**Addendum No. 1
To
Specifications
For Project No. ENG2003724395**

**Description: Bank Stabilization to Protect Parking Lot
Location: Charlestown State Park**

FOR AGENCY: Department of Natural Resources

ITEM No. 5: Approved Material Substitution Gradation Analysis

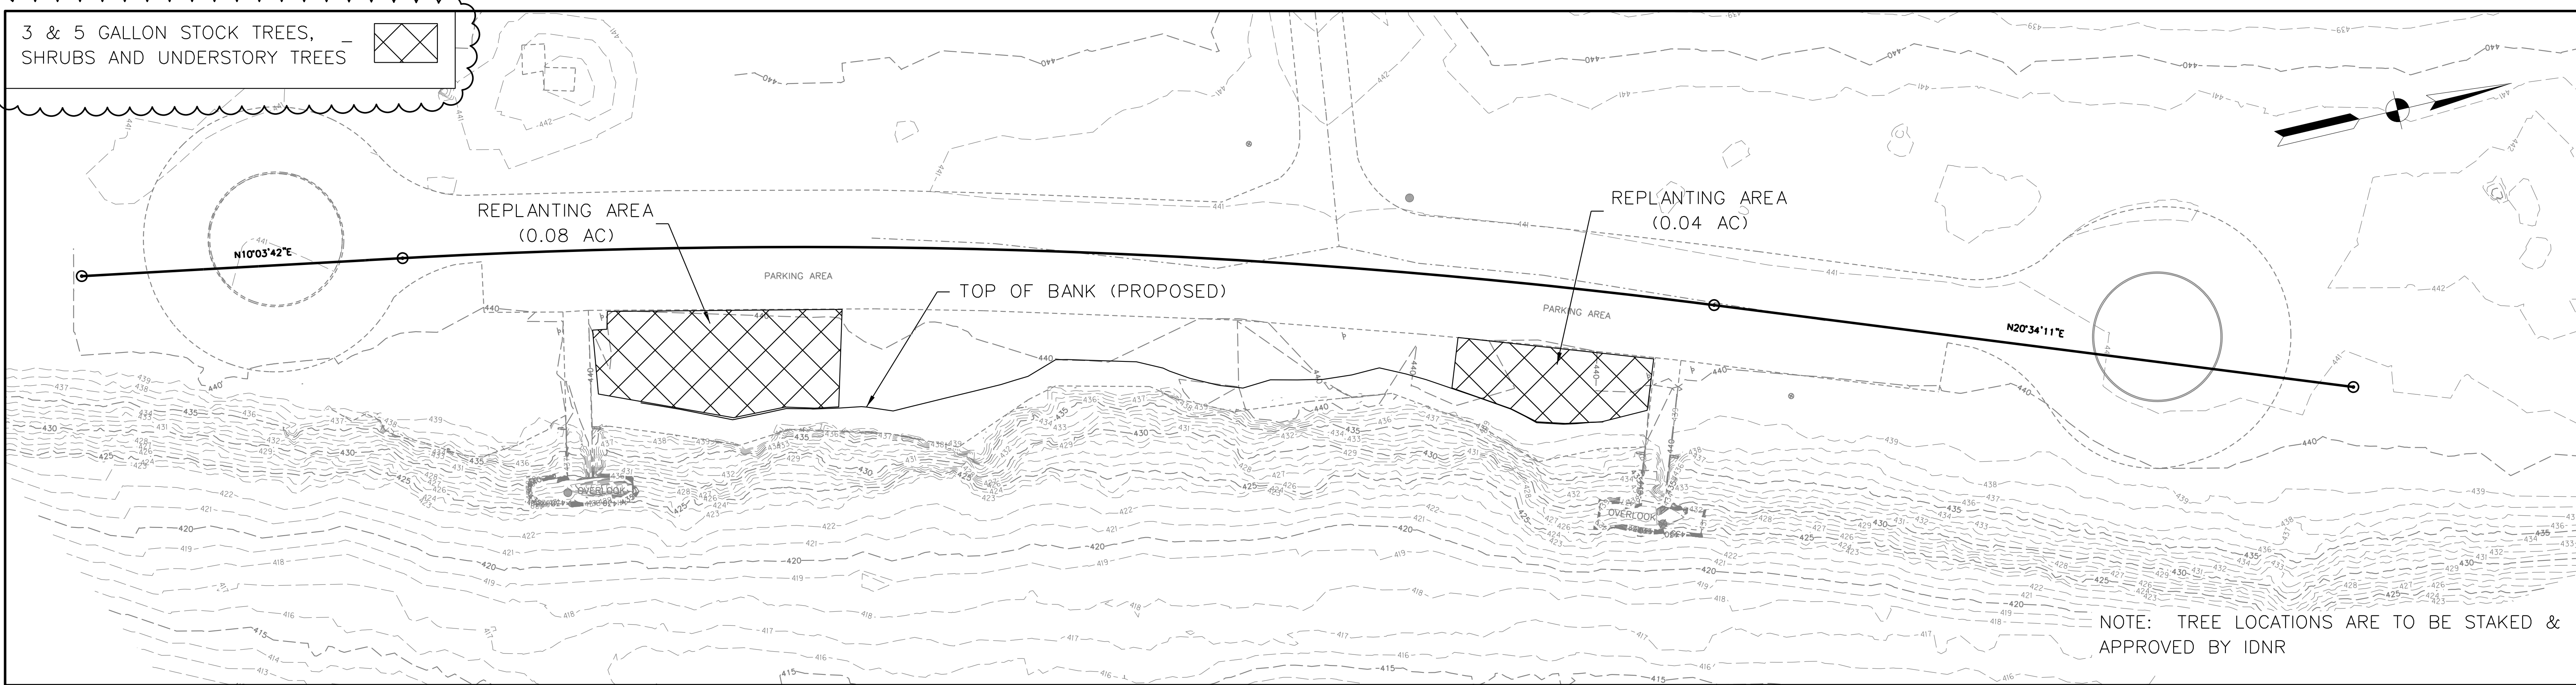
The attached gradation analysis is of a material that has been approved for the substitution of the #2 Stone and #53 Stone (50/50 Blend) subbase as shown in the plans. All Submittals, Quality Assurance, Placement, and Tolerances will conform to those set out in Section 31 05 16 of the specifications.
